Cloich Forest Wind Farm

SEI Report – Volume 3 – SEI Report Technical Appendices (Part 2 of 2)

**TECHNICAL APPENDIX A10.1:
SUPPLEMENTARY INFORMATION FOR PRIVATE WATER SUPPLY
RISK ASSESSMENT**

Proposed Cloich Forest Wind Farm: Applicant Response to SEPA Holding Objection

Revised Plate 1a: Stewarton surface water supply catchment

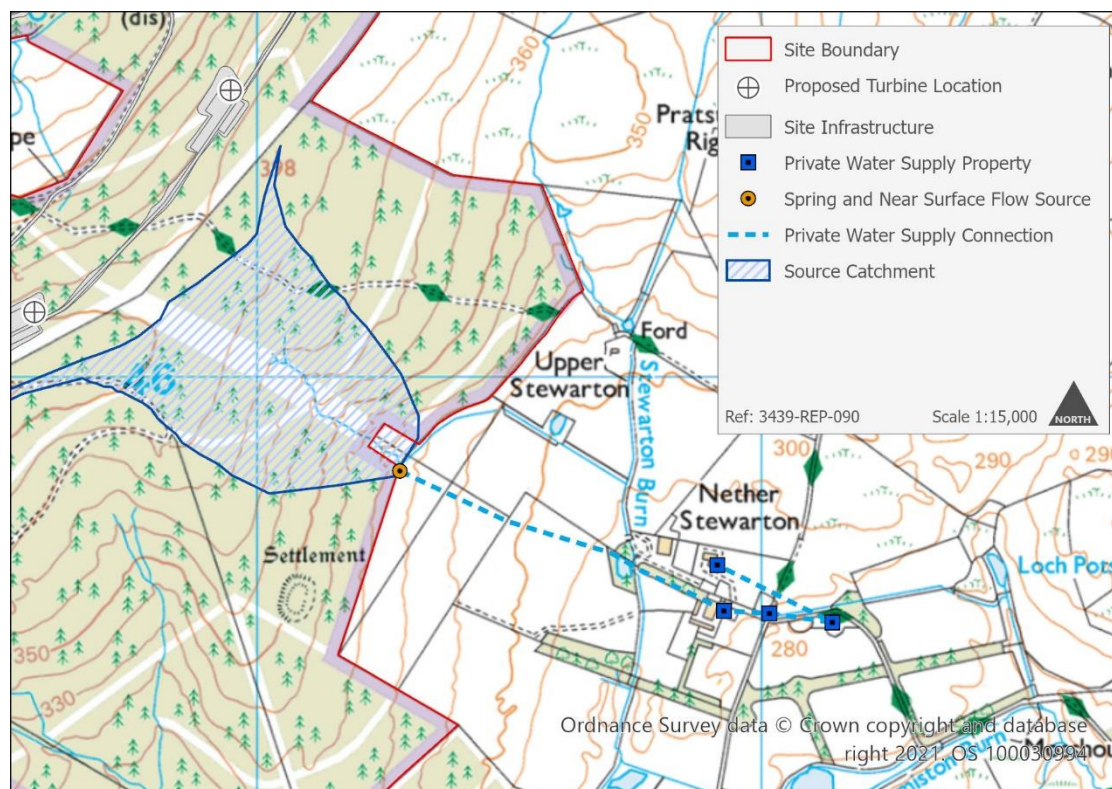
Plate 4a, 'Stewarton source catchment with surface water catchments', in Section 5.1.10 of the Private Water Supplied Risk Assessment (PWSRA) was intended to demonstrate that Nether Stewarton is served by two sources (groundwater and surface water).

Surface water: the surface water catchment is defined by topography i.e. blue hatched area shown on Plate 4a of the PWSRA. We recognise that trying to convey this much information on one plate may have led to some confusion, and may have inadvertently given SEPA the impression that the blue hatched area is in relation to groundwater catchments. This is not the case and this area notes the surface water catchment. Therefore, we have reproduced Plate 4a (below) to remove the 100 m and 250 m buffers, as well as the green dot which notes the spring (groundwater) source point, as neither are applicable to surface water abstractions in accordance with LUPS-GU31. The Revised Plate 4a, shown below, is now specifically in relation to surface water.

Revised Plate 10b: Stewarton source catchment with groundwater aquifer units

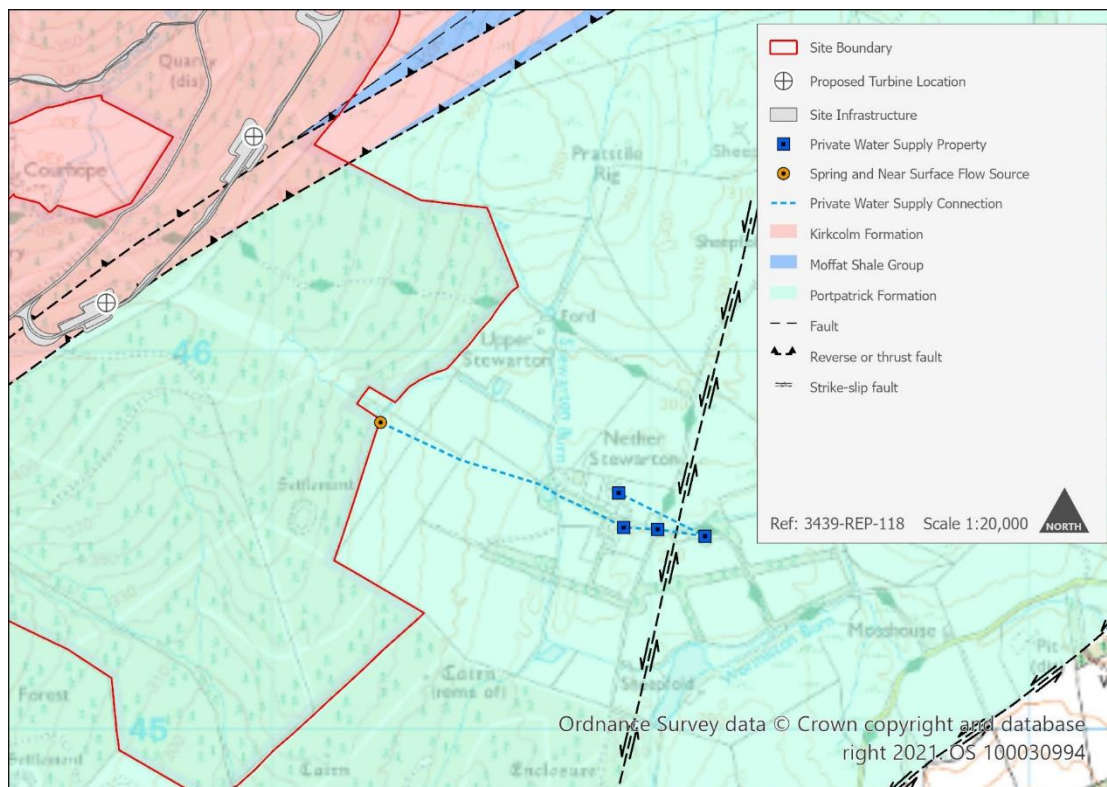
Groundwater: Plate 10a within the PWSRA was intended to support the PWSRA text in relation to groundwater. Due to the inconclusive nature of previous assessments and uncertainty regarding the extent of the groundwater unit from residents and previous reports, the Conceptual Site Model (CSM), presented in Section 5.1.10 and Plate 10d of the PWSRA (Revised Plate 10d shown below), assumed a worst case scenario that the groundwater table underlies T3; is within 3 m of the surface; and is potentially connected to the Nether Stewarton supply by the Leadhills Fault.

The PWSRA concluded that in the long-term, once the foundation for T3 has been completed and the exposed cut has been restored, it is anticipated that that near-surface water and groundwater will migrate around the turbine foundation, under gravity and by fracture flow.

Furthermore, a number of mitigation measures will be in place during turbine base construction to prevent the ingress of concrete and other liquids, such as blinding concrete at the base of the excavation prior to concrete pouring and other good practice measures.
